## **ADDENDUM TWO**

Project No.: **PROJECT NUMBER 22-020  
IFB NO. 22B-2240**

Subject: **CHANGES TO BIDDING DOCUMENTS**

Project: **ADDITION & RENOVATIONS WORK AT  
WINNEBAGO COUNTY ANIMAL SERVICES  
ROCKFORD, ILLINOIS**

G101
OF
3

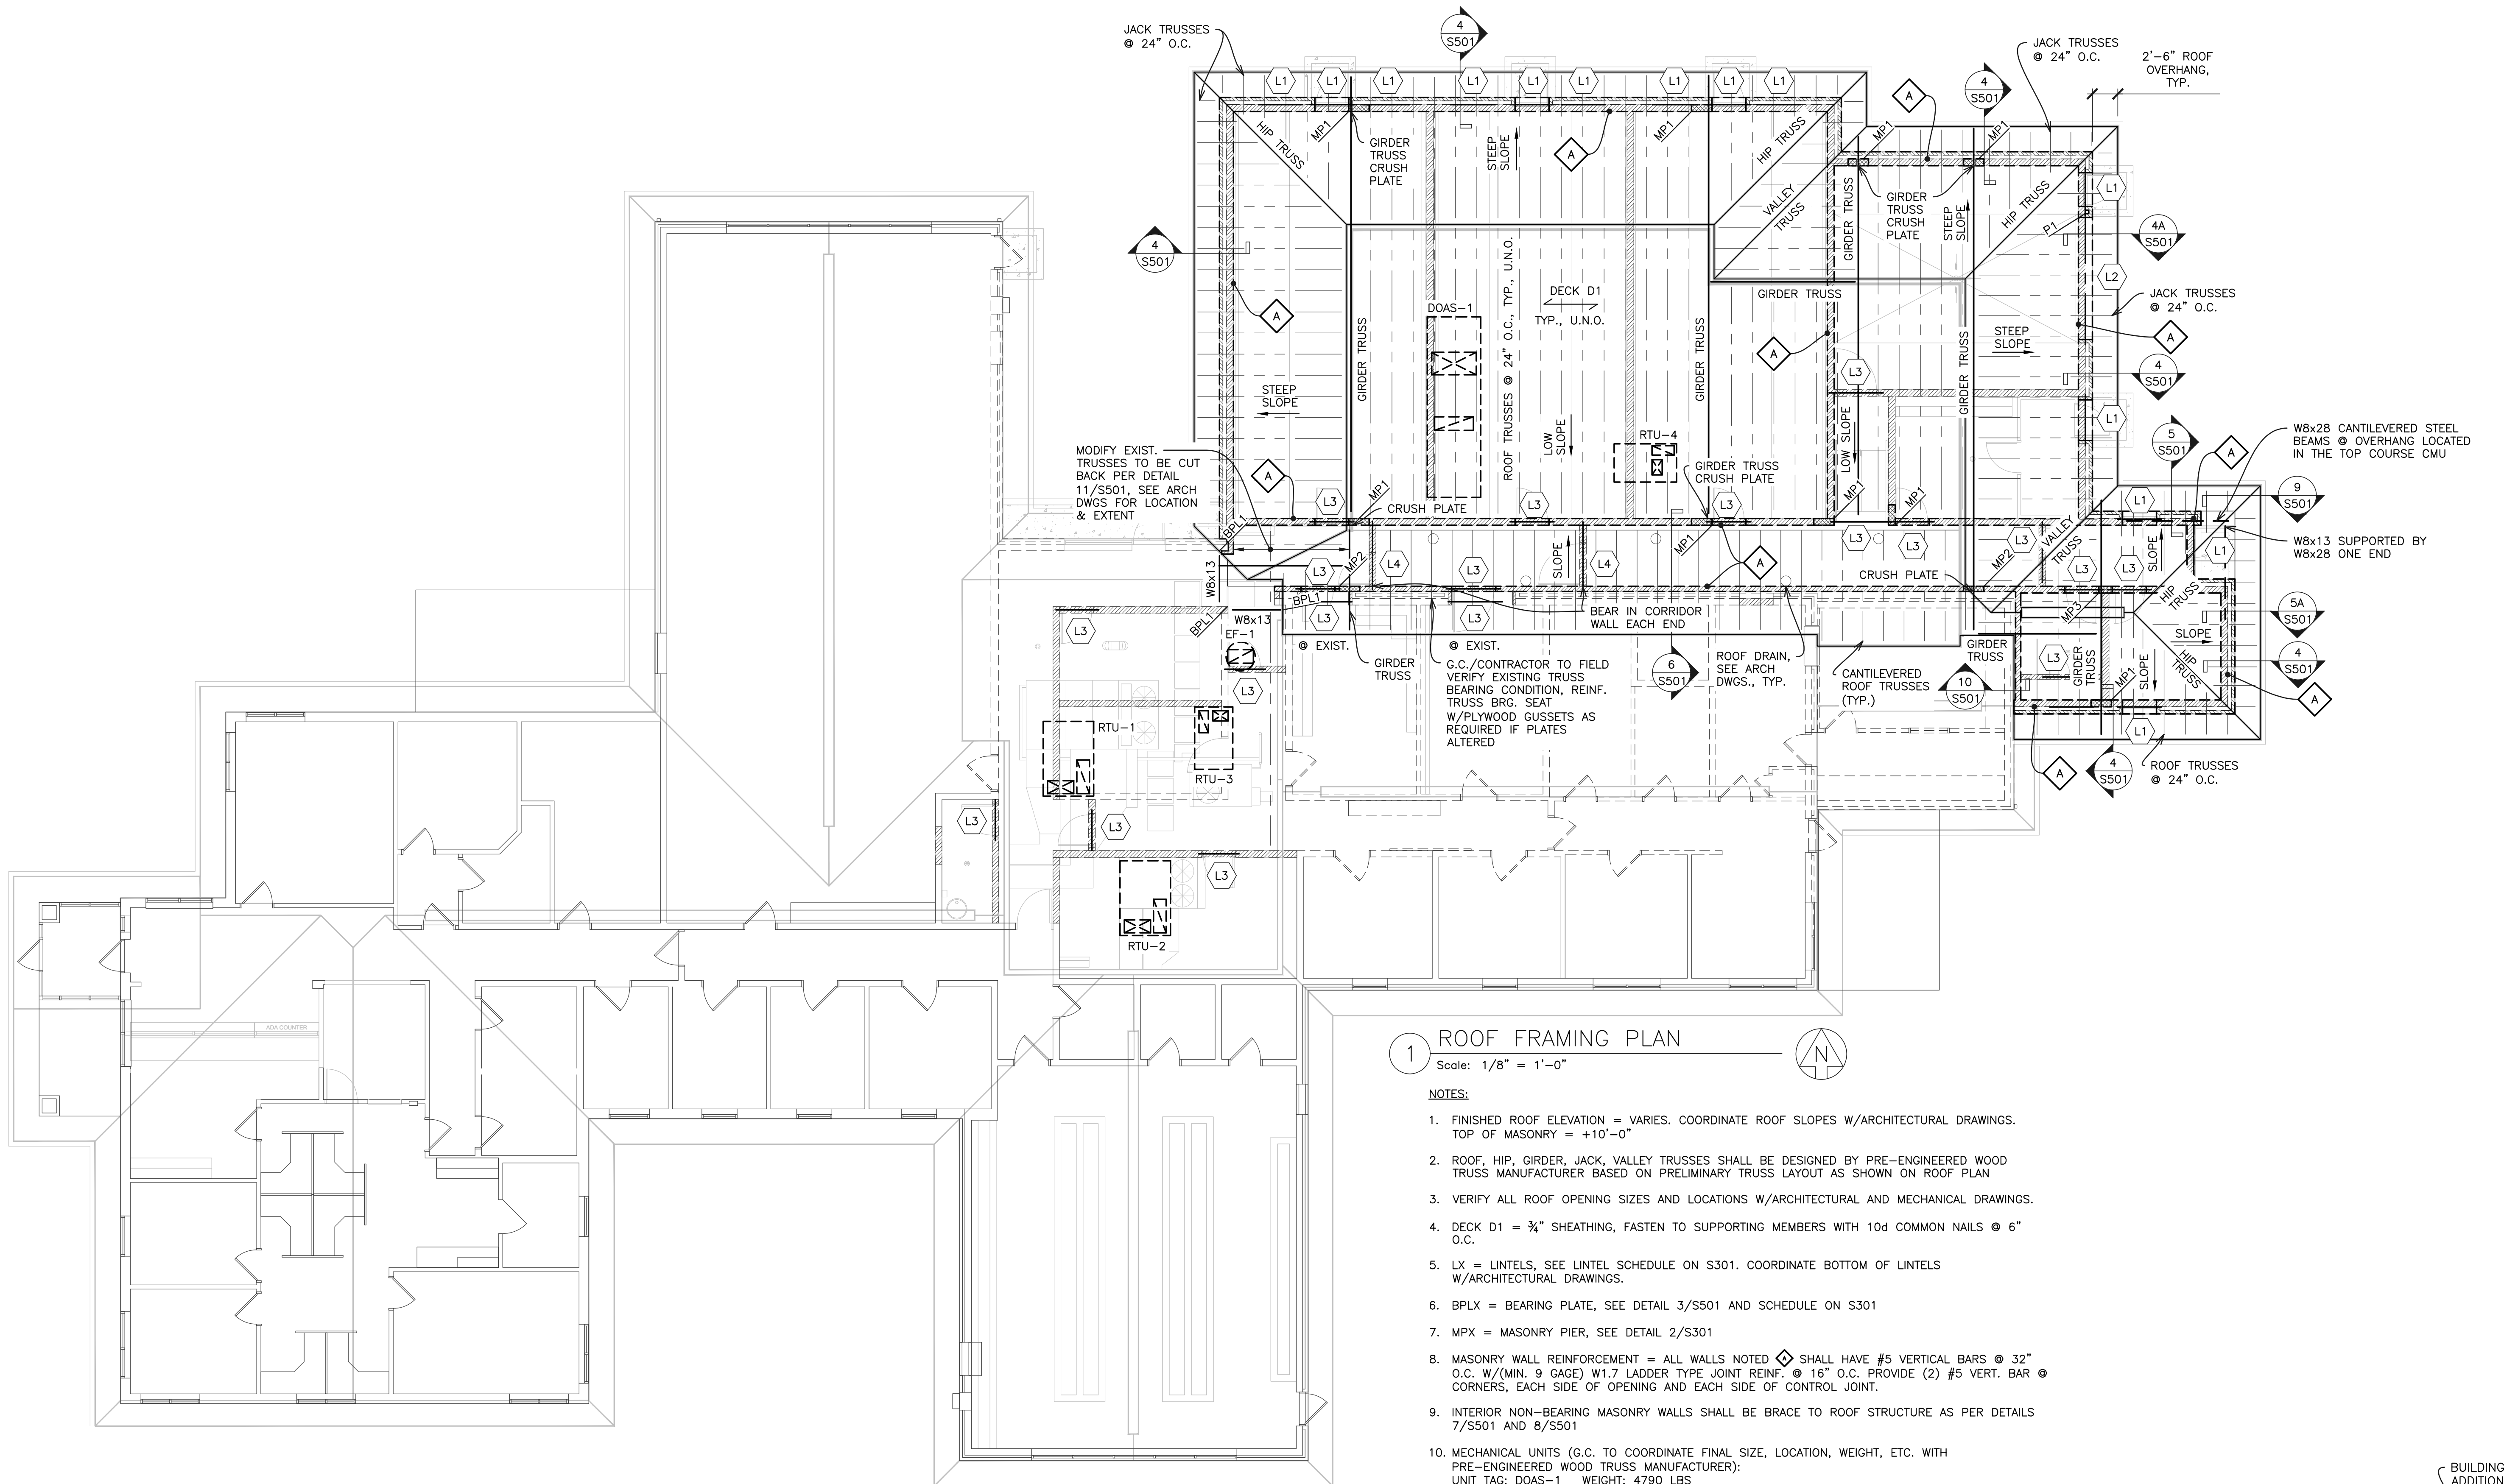
#### 3.1. Delete sheet G101 and replace it with attached sheet G101 with a revision date September 8, 2022.

- Room Finish Schedule, Note 2 was added and applies to Dog Ward Rooms A19, A22 and A25.

NOTE 1: REMOVE AND REPLACE DAMAGED GYP CEILINGS AS REQUIRED - PAINT
NOTE 2: ALL FOUR WALL TO RECEIVE ACOUSTICAL WALL PANELS. PANELS SHALL BE NOTCHED AROUND DOOR AND WINDOW FRAMES

PROJECT INFORMATION		SHEET IDENTIFICATION	
Date	August 16, 2022	ROOF FRAMING PLAN	
Rev. Date	Sept. 8, 2022	SHEET NUMBER	
Rev. Date	Sept. 8, 2022	S201	
Rev. Date	Sept. 8, 2022	OF	
Rev. Date	Sept. 8, 2022	11	
Rev. Date	Sept. 8, 2022	11

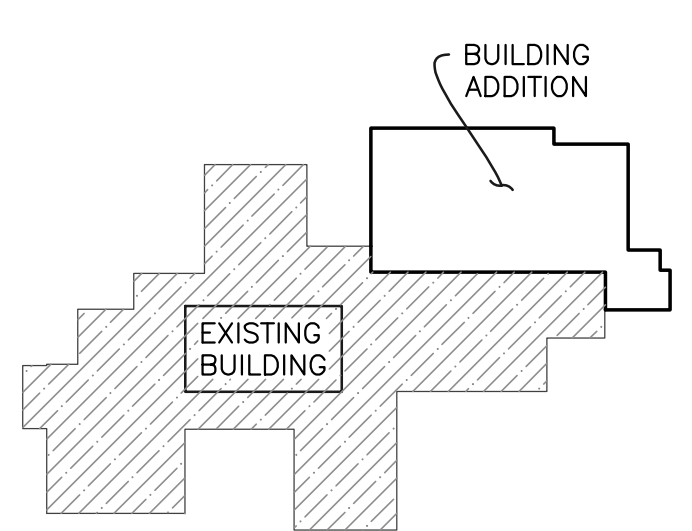
#### 4.1. Delete sheet S201 and replace it with attached sheet S201 with a revision date September 8, 2022.

- Note 12 was added, reinforcement of interior non-loadbearing walls.

11. P1 = HSS4x4x1/4 WITH 1/2"x8"x10" BASE PLATE WITH (2) 3/4" HILTI KWIK BOLT 3
  12. MASONRY WALL REINFORCEMENT INTERIOR NON-BEARING WALLS = #5 VERTICAL @ 48" O.C. W/(MIN. 9 GAGE) W1.7 LADDER TYPE JOINT REINF. @ 16" O.C. PROVIDE (2) #5 VERT. BAR @ CORNERS, EACH SIDE OF OPENING AND EACH SIDE OF CONTROL JOINT, TYP., U.N.O.

### 1 MASONRY SHEAR WALL

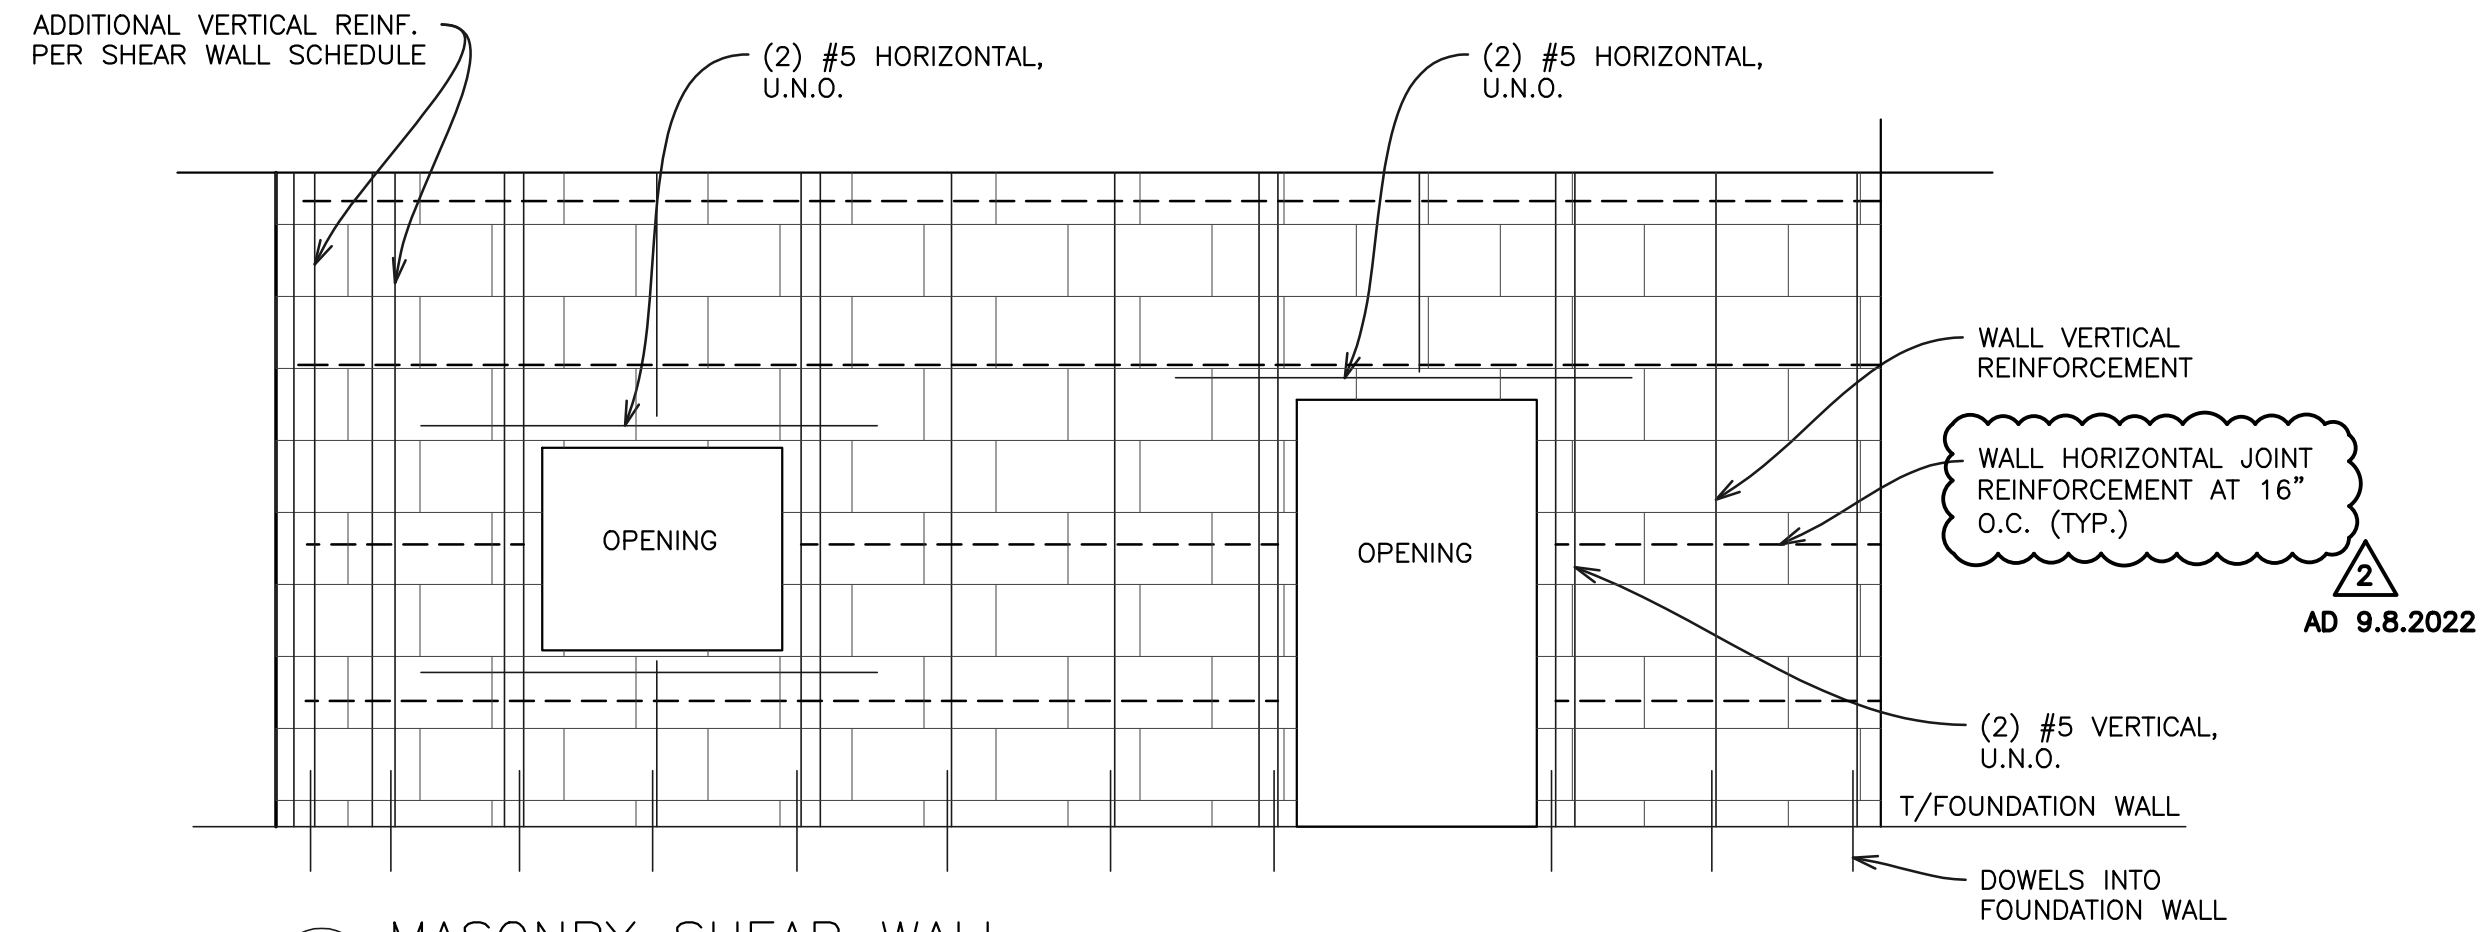
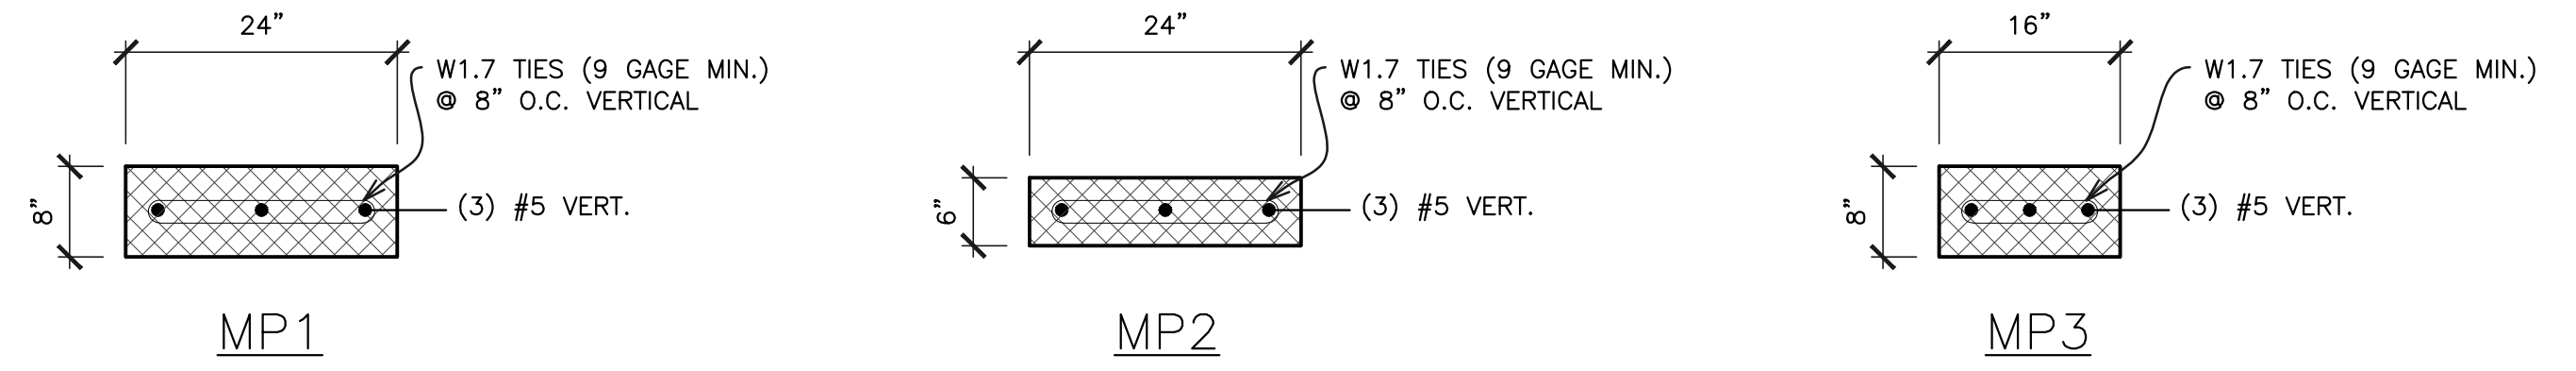
#### 5.1. Delete sheet S301 and replace it with attached sheet S301 with a revision date September 8, 2022.

- Masonry Shear Wall, Horizontal joint reinforcing note was revised.
